Preparation Support for Lelystad Airport Consultation

Report for LVNL

Document title	Preparation Support for Lelystad Airport Consultation Report for LVNL
Author	Helios
Produced by	Helios 29 Hercules Way Aerospace Boulevard - AeroPark Farnborough Hampshire GU14 6UU
Produced for	LVNL
Helios contact	Alan Corner Tel: +44 1252 451 651 Fax: +44 1252 451 652 Email: Alan.Corner@askhelios.com
Version	V1.0
Date of release	06 September 2017
Document reference	P2386D009

Figure 6: Lelystad Airport TMA

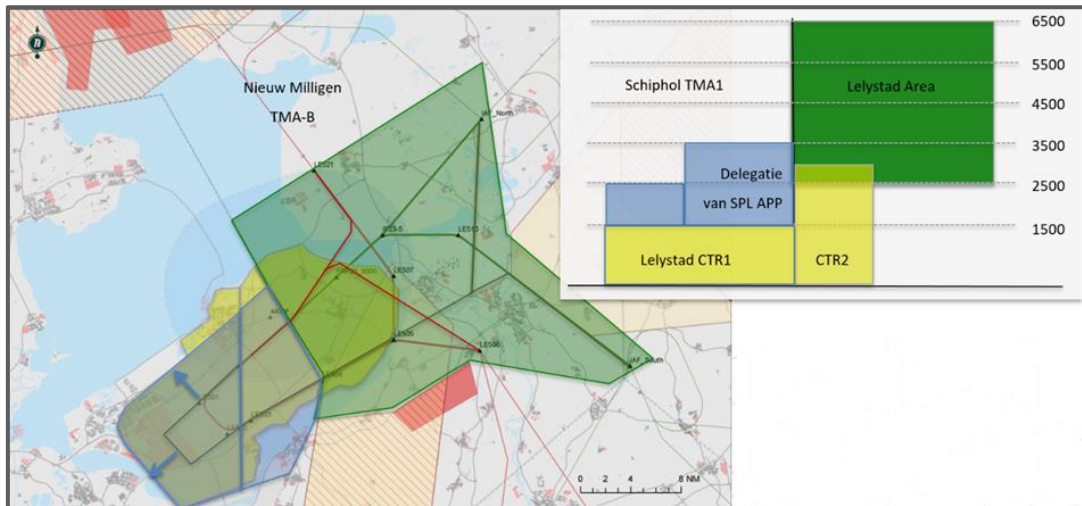
Evidently, the Lelystad airport TMA design appears to show adequate lateral containment of the Conops B+ arrival and departure routes.

Figure 7: Vertical profiles of the arrival (green) and departure procedures (red) for Runway 05

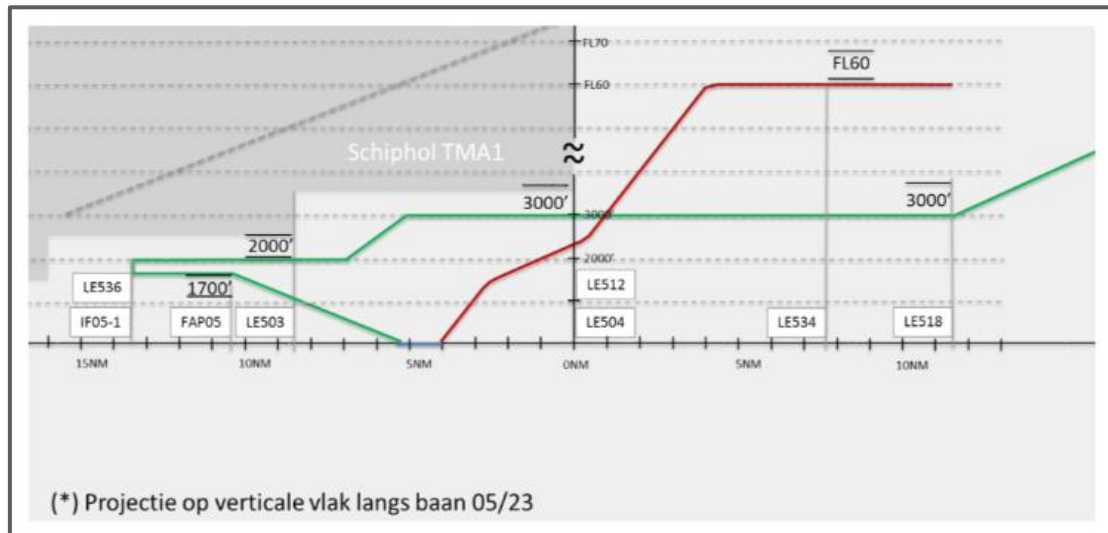
The departure procedures are shown climbing from threshold elevation to FL060 (approx. 6000ft) over a distance of approximately 11.5 NM (to waypoint LE534); this equates to a PDG of circa 8.5%. Whereas, the arrival procedure involves a series of shallow stepped descents culminating in a final uninterrupted descent from an altitude of 1700ft to threshold over a distance of approximately 6 miles; this equates to a descent gradient of circa 5.2% (3 degrees). All conceptual design gradients therefore fall within PANS OPS criteria.

Figure 8: Vertical profiles of the arrival (green) and departure procedures (red) for Runway 23

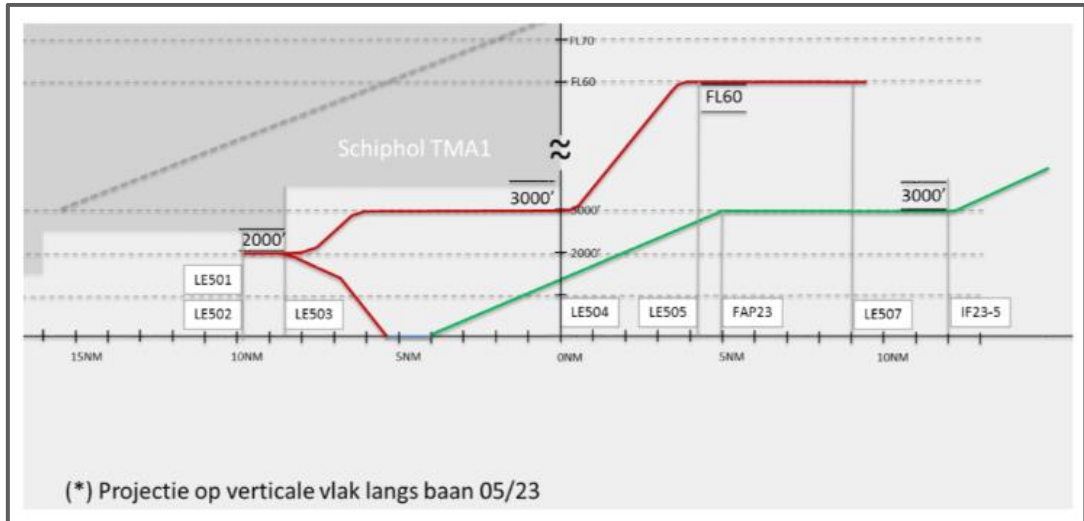
The departure procedures are shown with a series of interrupted climbing segments in order to keep departing aircraft within the stepped vertical limits of the TMA. The steepest portion involves a climb from altitude 3000ft to 6000ft over a distance of approximately 5 NM; this equates to a PDG of circa 9.9%. Whereas, the arrival procedure involves a series of shallow stepped descents culminating in a final uninterrupted descent from an altitude of 3000ft to threshold over a distance of approximately 8 NM; this equates to a descent gradient of circa 5.2% (3 degrees). All conceptual design gradients fall within PANS OPS criteria.

Figure 9: Vertical cross section of Lelystad TMA

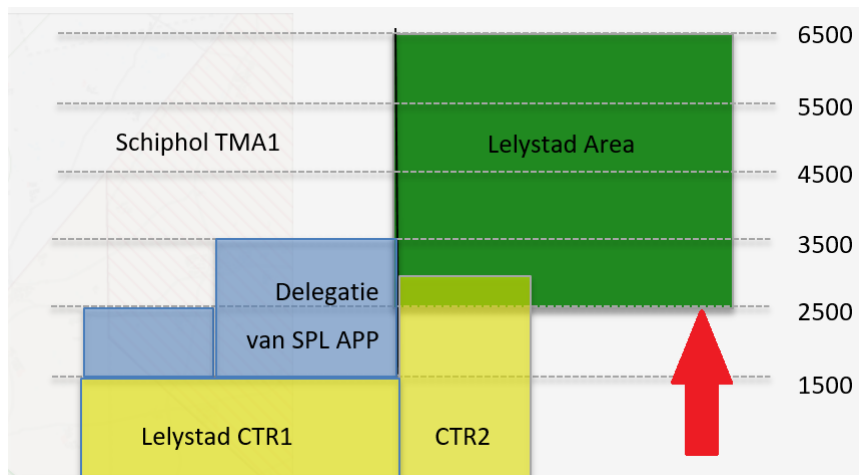
We note that whilst the Lelystad TMA achieves vertical containment of the Conops B+ routes, the base level of the Lelystad airport TMA in the vicinity of the Initial Approach Fixes at 2,500ft (as shown below in Figure 9) seems unnecessarily low, when the stated requirement is for inbounds to maintain a minimum of FL060 and to descend to 3,000ft 'as late as possible'.
